RE: Enduring Resources, LLC
Southam Canyon 10-25-22-32
SENW Sec 32-10S-25E
Uintah County, Utah
Lease # ML-47065

APPLICATION FOR PERMIT TO DRILL				5. MINERAL LEASE NO: ML-47065	6. SURFACE: State
1A. TYPE OF WORK: DRILL <input checked="" type="checkbox"/> REENTER <input type="checkbox"/> DEEPEN <input type="checkbox"/>				7. IF INDIAN, ALLOTTEE OR TRIBE NAME:

Well name:	03-06 Enduring Southam Cyn 10-25-22-32	
Operator:	Enduring Resources, LLC	Project ID:
String type:	Surface	43-047-37795
Location:	Uintah County

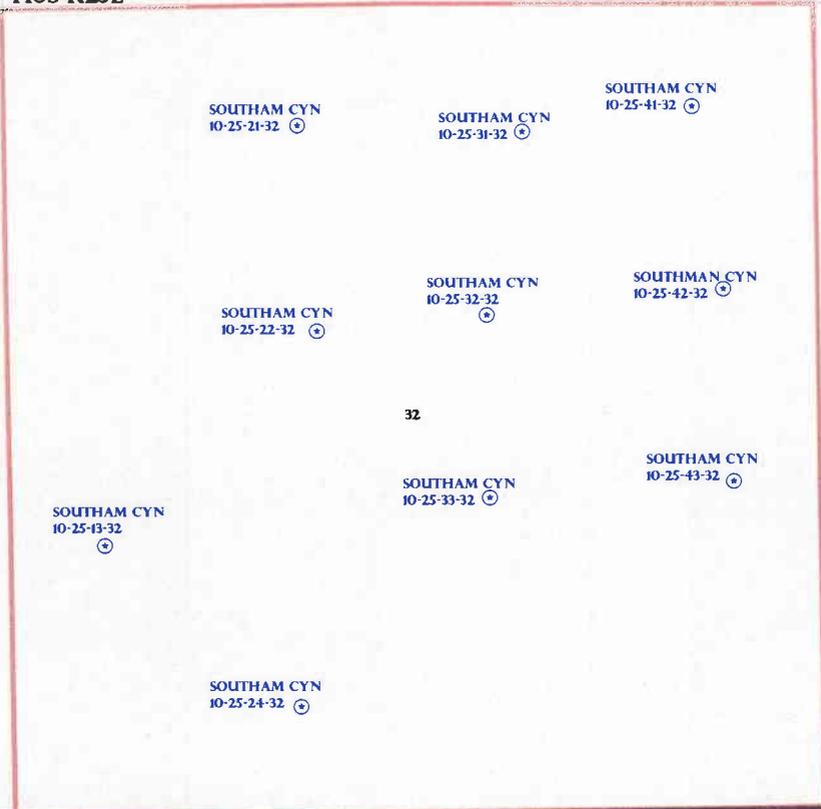
COMMENTS:

Needs Precise (03-07-06)
